ADDENDUM NO. 1

March 21, 2025

**Ascension Catholic Secondary School Renovation
PROJECT NO. 24137
HOSSACK ARCHITECTURE**

Halton Catholic District School Board
Renovations to Ascension Catholic Elementary School
Hossack Architecture
Project No. 24137

DATE:	FEBRUARY 2025
SCALE:	1:100
DRAWN BY:	AS
CHECKED BY:	MA
DWG STATUS:	TENDER
PROJECT No.:	2025-476
DRAWING No.:	E3.1-A-1
REVISION:

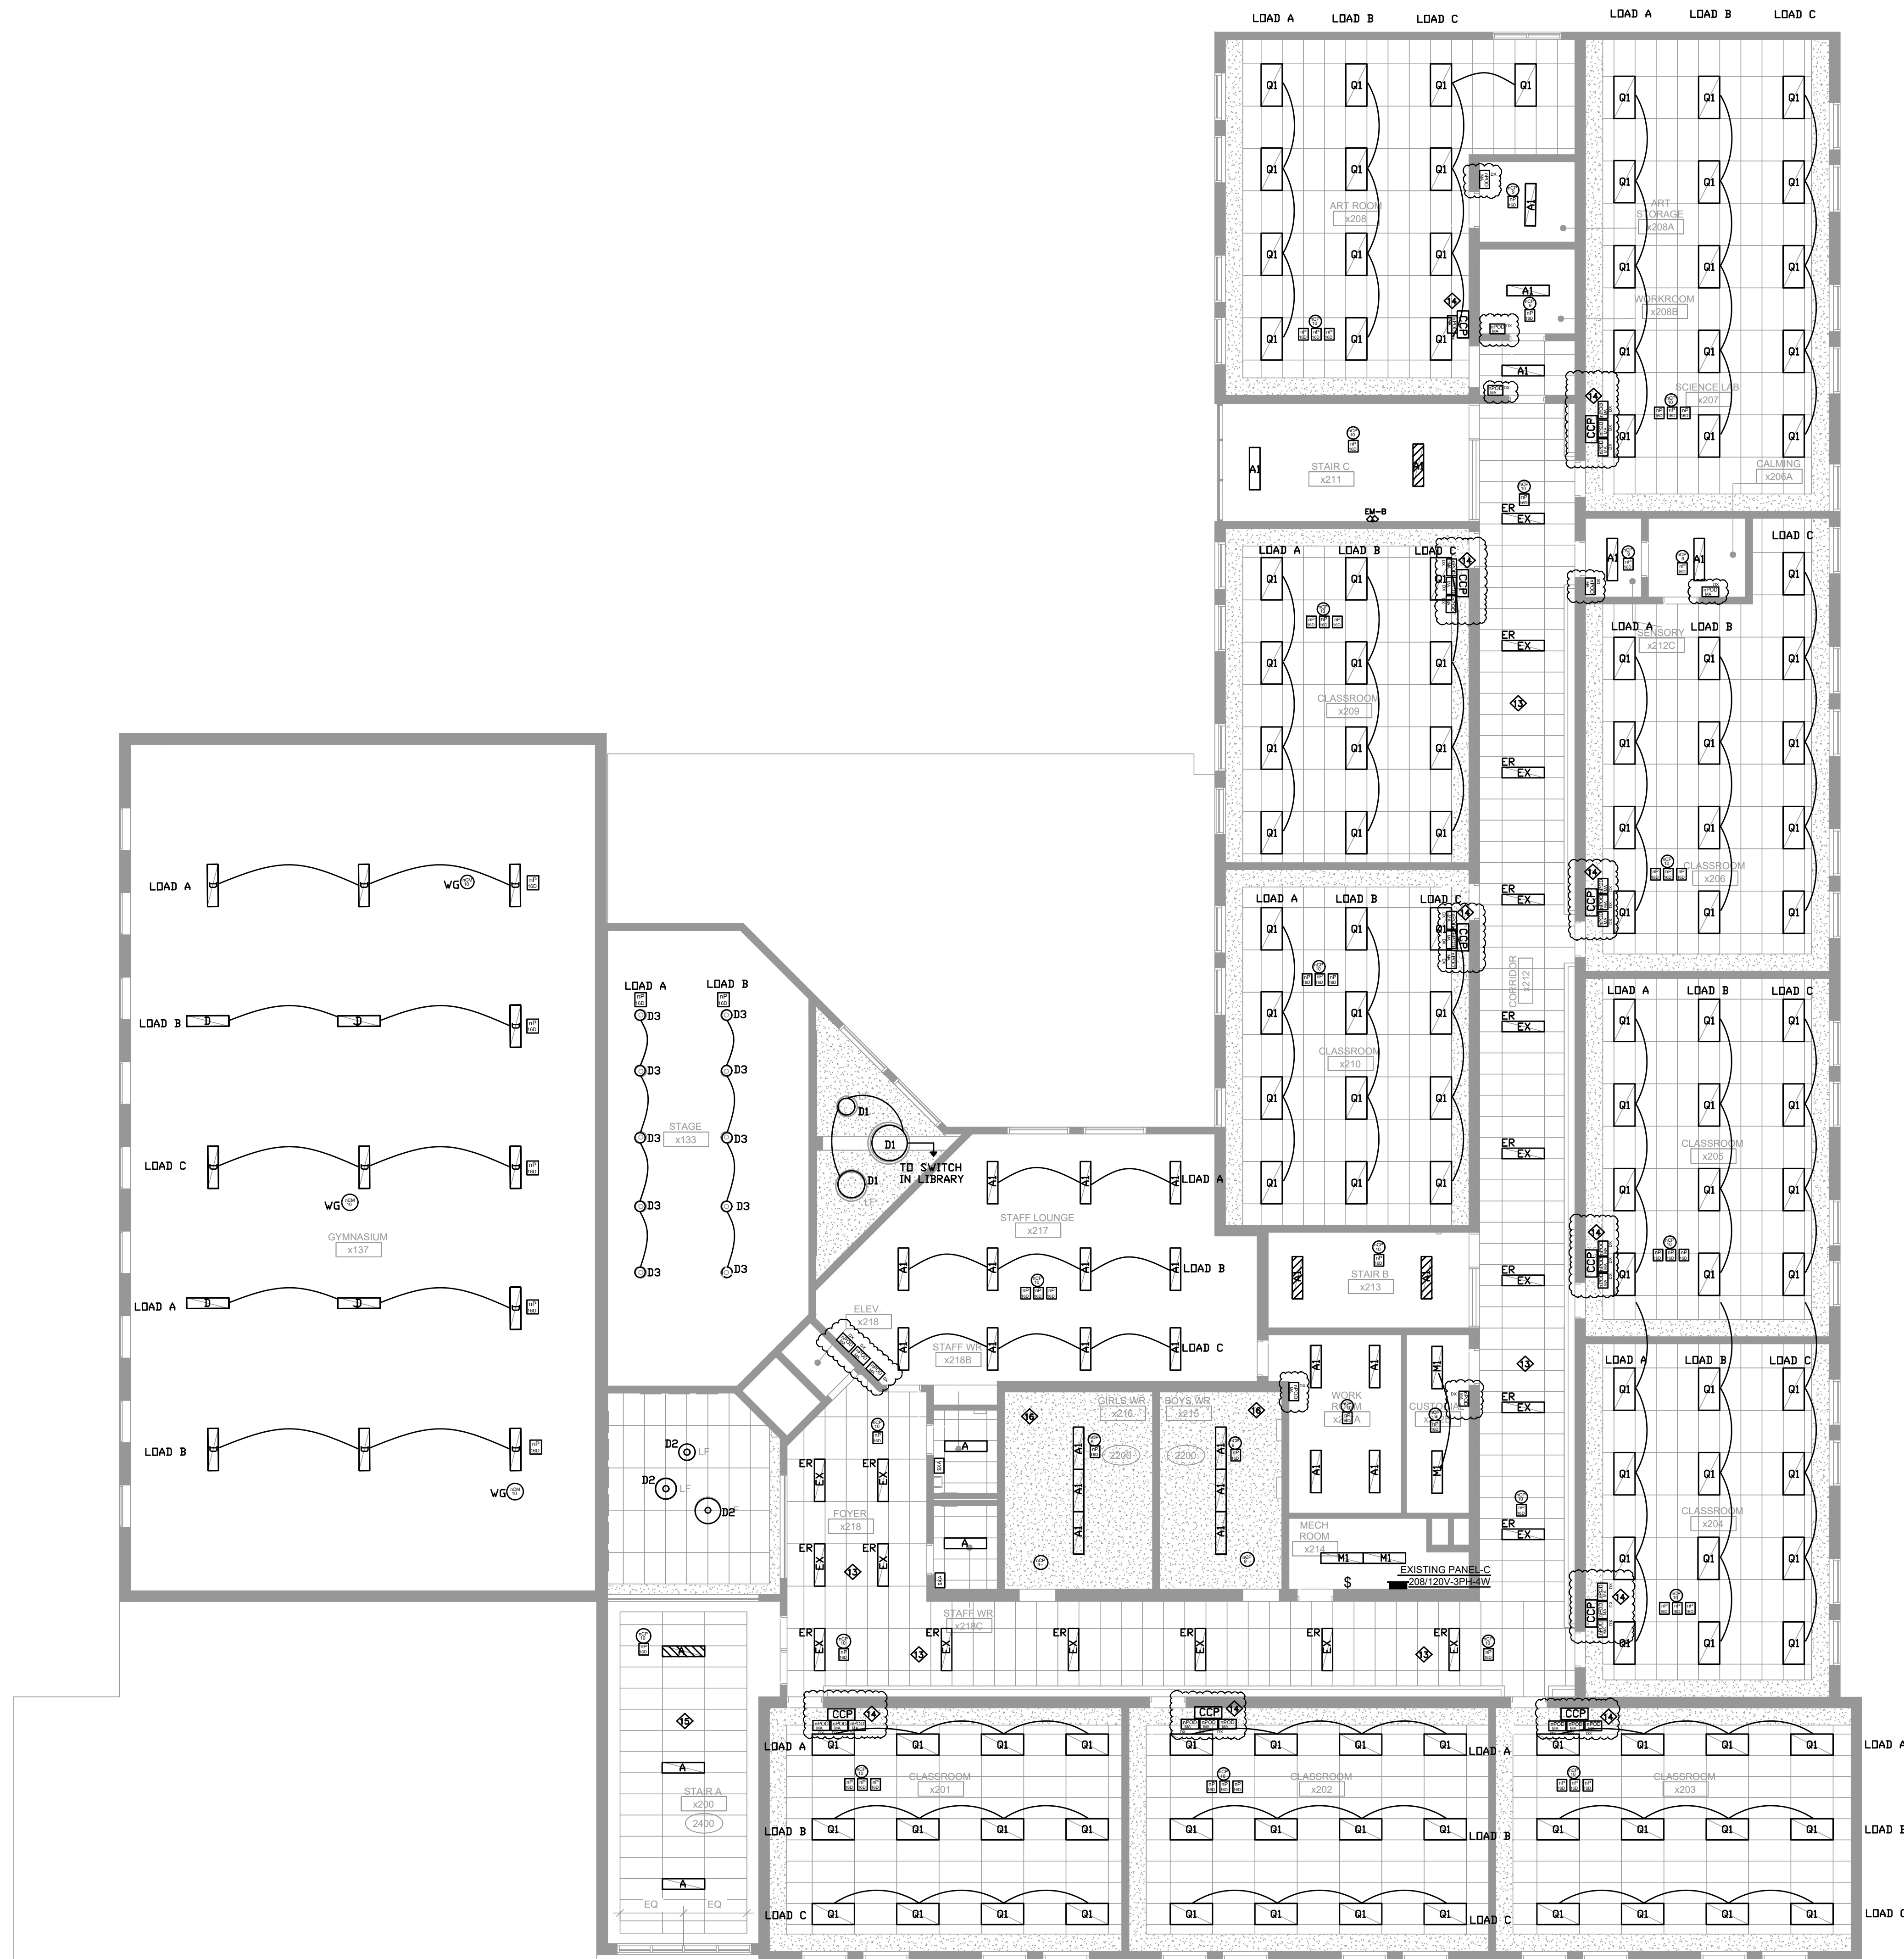
1. Replace/add the drawings with as under:
 1. Lighting fixtures by Peerless Electric shall be treated as equal.
 2. Find attached revised electrical drawing E1.0-A-1 with changes shown as clouded.
 3. Find attached revised electrical drawing E2.0-A-1 with changes shown as clouded.
 4. Find attached revised electrical drawing E2.1-A-1 with changes shown as clouded.
 5. Find attached revised electrical drawing E3.0-A-1 with changes shown as clouded.
 6. Find attached revised electrical drawing E3.1-A-1 with changes shown as clouded.
